RE: Marsh Landing Generating Station
Application for Certification 08-AFC-03

**Subject: Addendum to Facility Investigation and Risk Assessment Work Plan
Marsh Landing Generating Station
Mirant Contra Costa Power Plant
Contra Costa County, California**

Subject: Addendum to Facility Investigation and Risk Assessment Work Plan
Marsh Landing Generating Station
Mirant Contra Costa Power Plant
Contra Costa County, California

PROPOSED SAMPLING LOCATIONS
Marsh Landing Generating Station
Mirant Contra Costa Power Plant
Contra Costa County, California

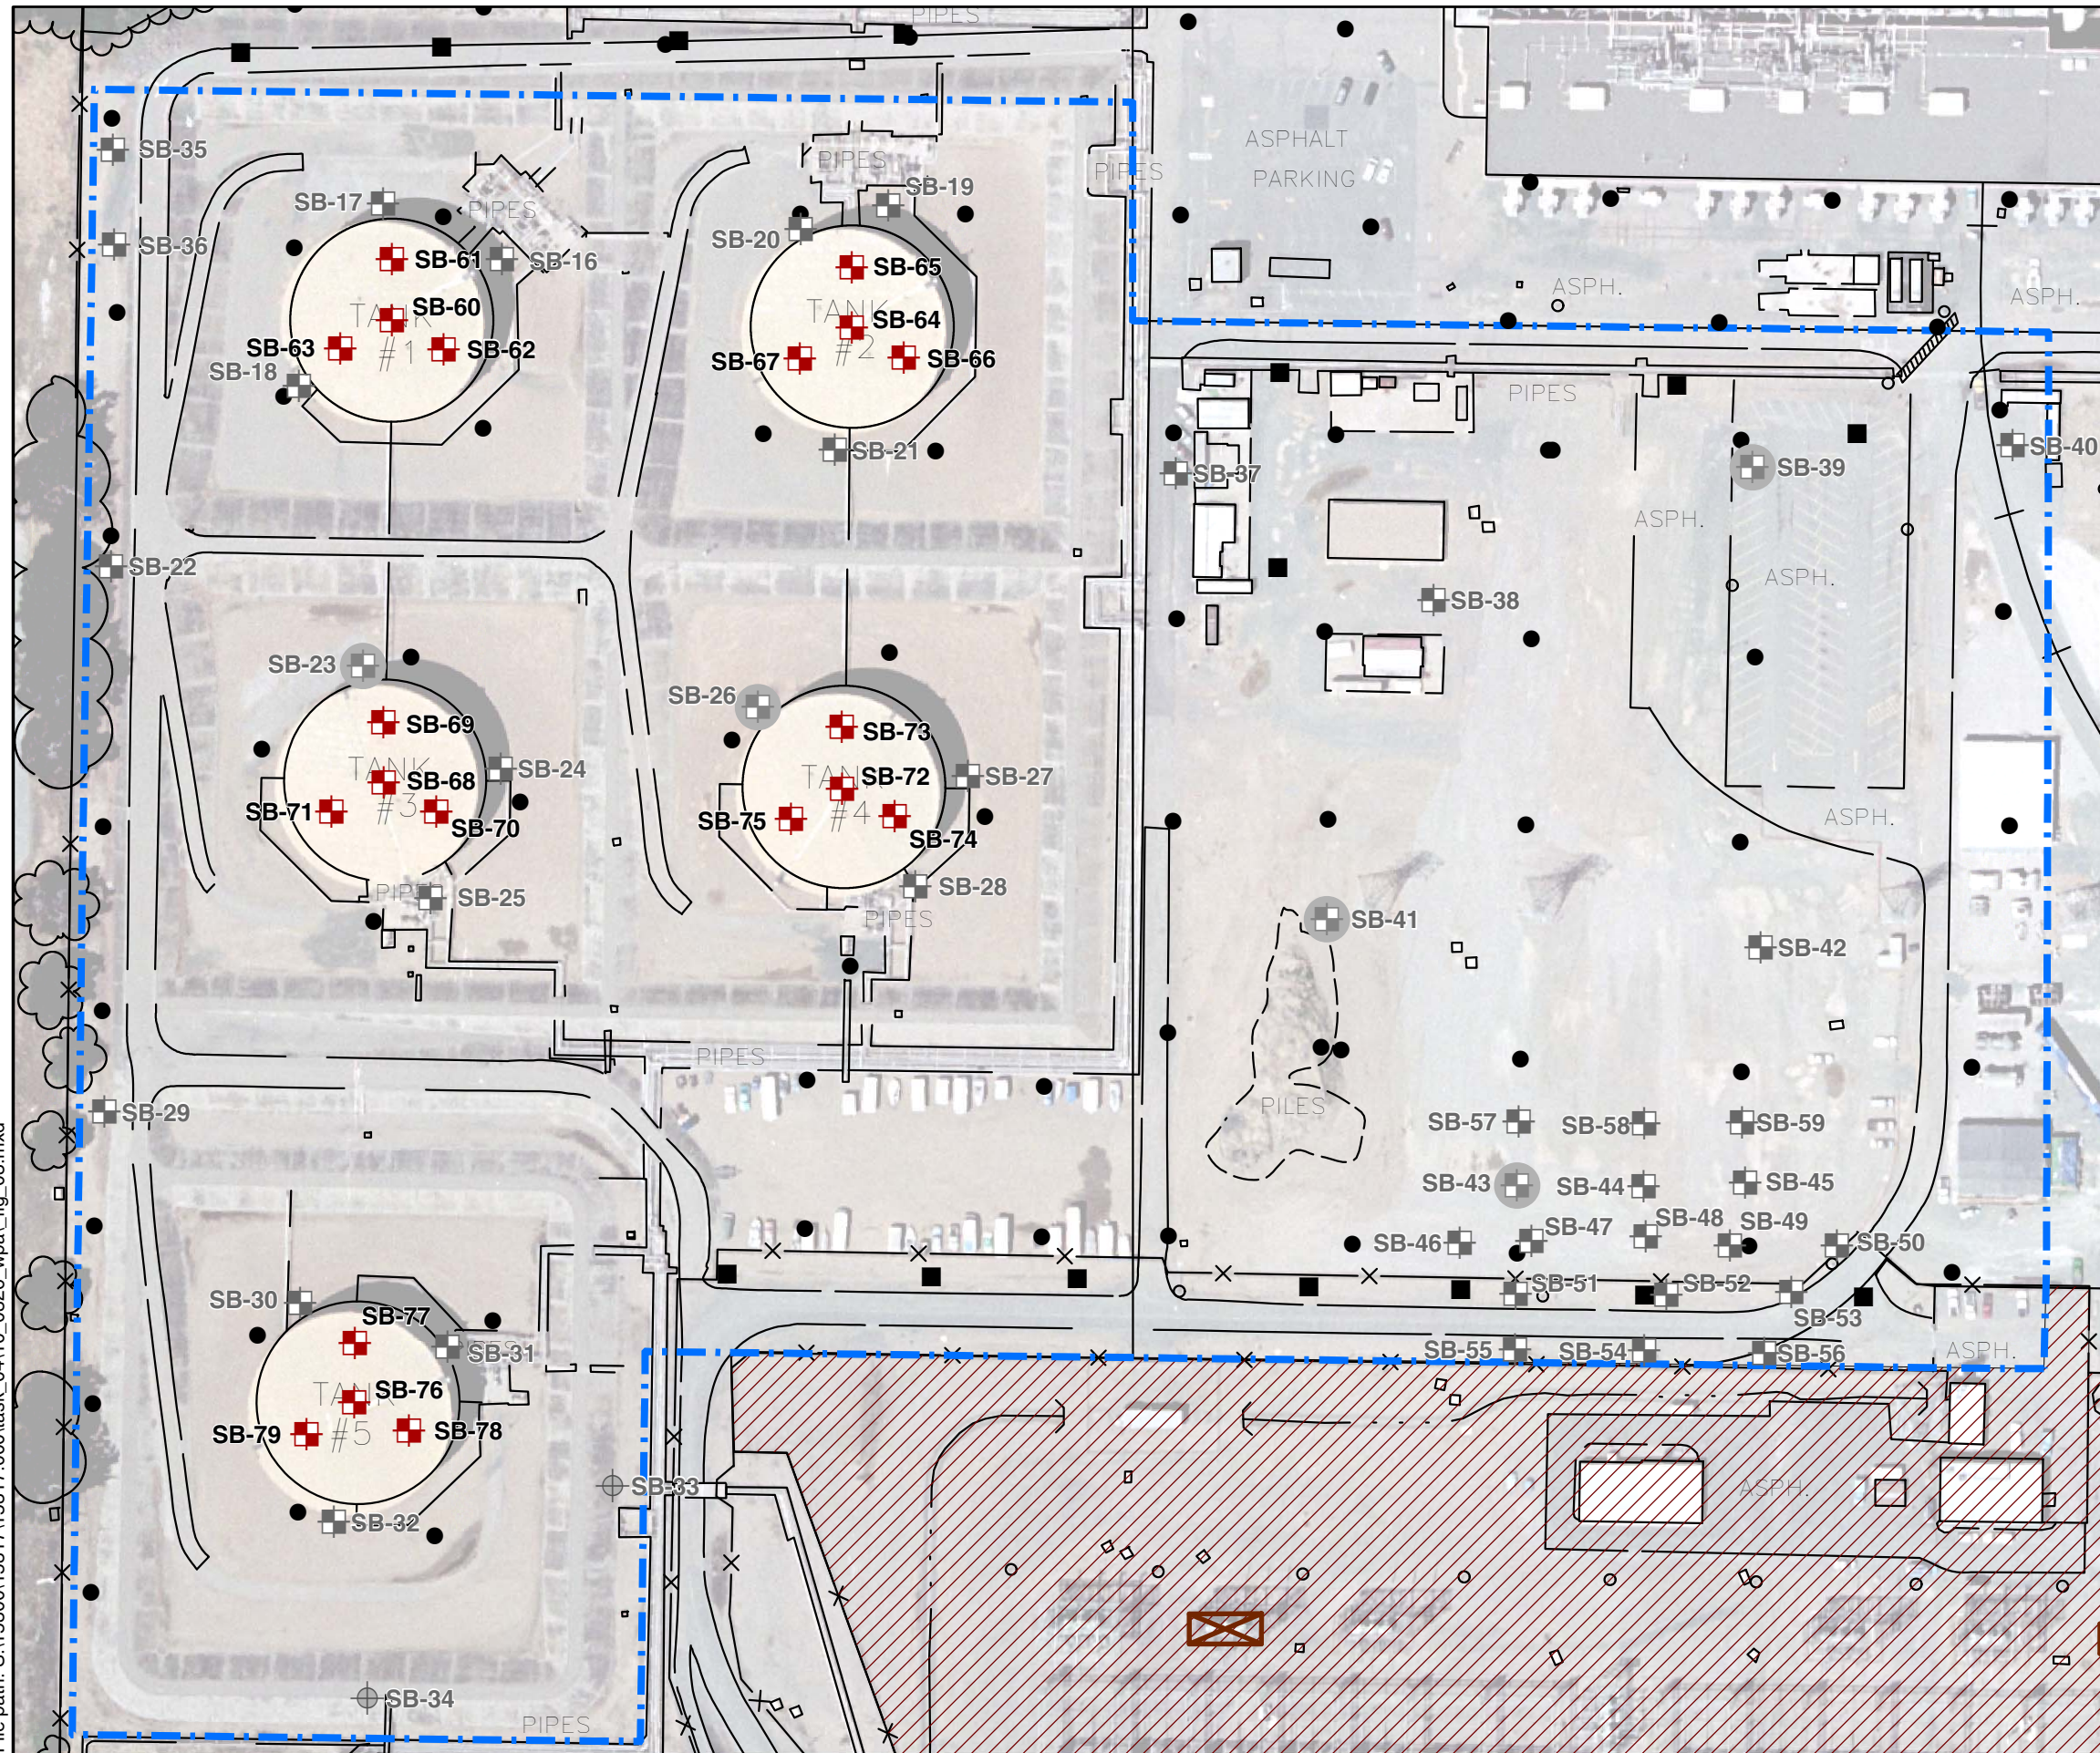
To accomplish the objective outlined above, AMEC proposes to collect soil samples at a minimum of four locations per tank footprint (borings SB-60 through SB-79; Figure 3). In general, the tank footprint will be divided into thirds and a boring will be advanced in the middle of each section. A boring will be advanced in the center of the tank footprint, as well. However, if stained soil is observed, those locations will be targeted for sampling, and additional borings may be advanced based on field observations. Pre-field activities and sampling methodology will be conducted as described in the Work Plan. Soil borings will be advanced using a hand auger to a depth of 5 feet below ground surface (bgs) and soil samples will be collected from each boring at depths of 1, 3, and 5 feet below the aggregate base tank foundation. The sample collected from 5 feet bgs will be placed on hold pending the analytical results of the shallower samples. A revised sampling and analysis plan that includes the additional proposed samples is presented in Table 1.
